ADDENDUM No. 1

Project	T.A. Blakelock H.S. Renovations - Phase 1	Project No.	2215A
Location	1160 Rebecca Street, Oakville, Ontario	Date of Issue	2023 03 27
Owner	Halton District School Board	File	2215/7.1.3

This Addendum forms part of the Contract Documents and amends the original Drawings and Specifications, dated 2023 03 16, as noted below.

11 MD11
A801 1:10

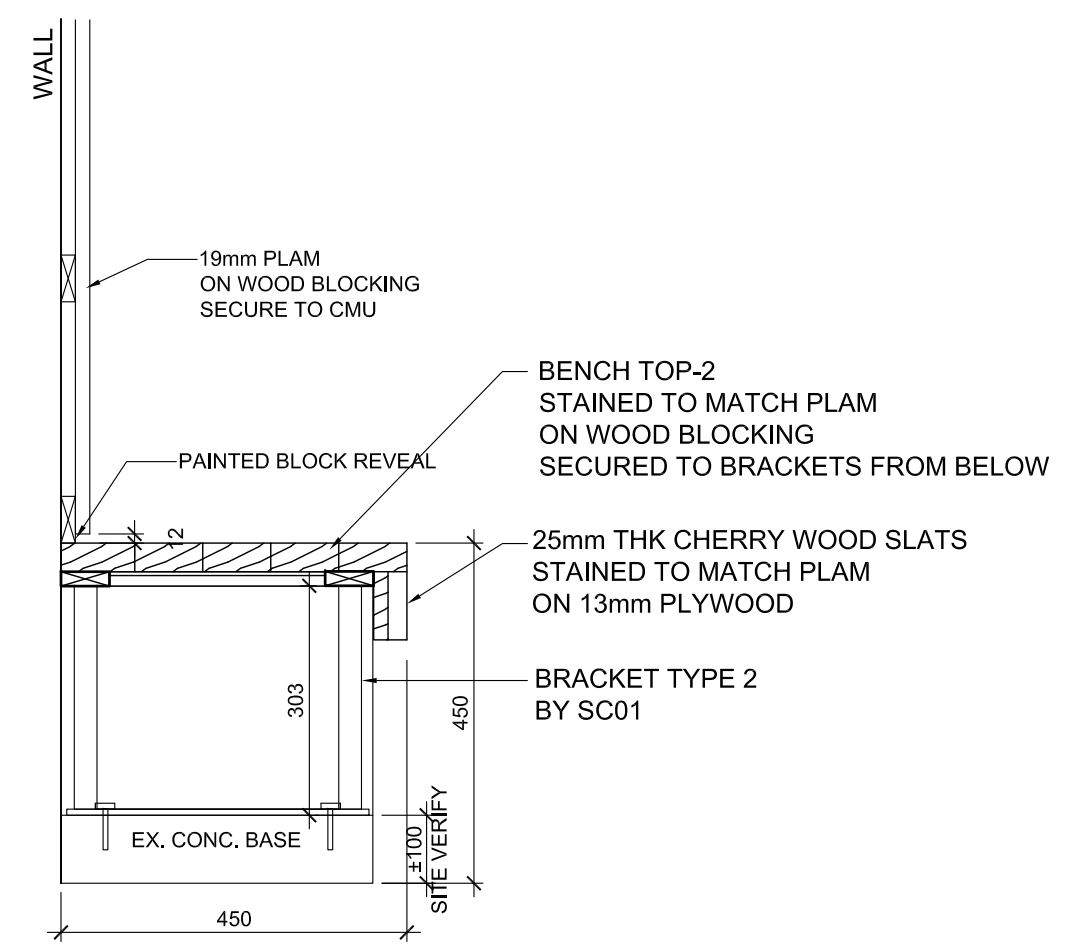
.1 Revise “*Typical Millwork Construction*” notes, and “*Millwork Notes*” to match text as per attached Drawing A801 Millwork Details, Revision No. 1

TYPICAL MILLWORK CONSTRUCTION

- MILLWORK NOTES:**
- PROVIDE CONTINUOUS BLOCKING BEHIND MILLWORK AS NECESSARY; SEAL ALL MILLWORK @ WALL / FLOOR INTERSECTIONS. UNITS TO BE PROVIDED WITH FILLER PANELS, SIZES AS REQUIRED, TO ENCLOSE ENDS AT ADJACENT UNITS OR WALLS.
 - SLIDE BOLTS: PROVIDE TOP AND BOTTOM SLIDE BOLT ON THE LEFT DOOR FOR ALL TALL CUPBOARDS.
 - ALL MILLWORK DOORS AND DRAWERS TO BE LOCKABLE.
 - ALL FASTENERS TO BE NON-CORROSIVE TYPE.
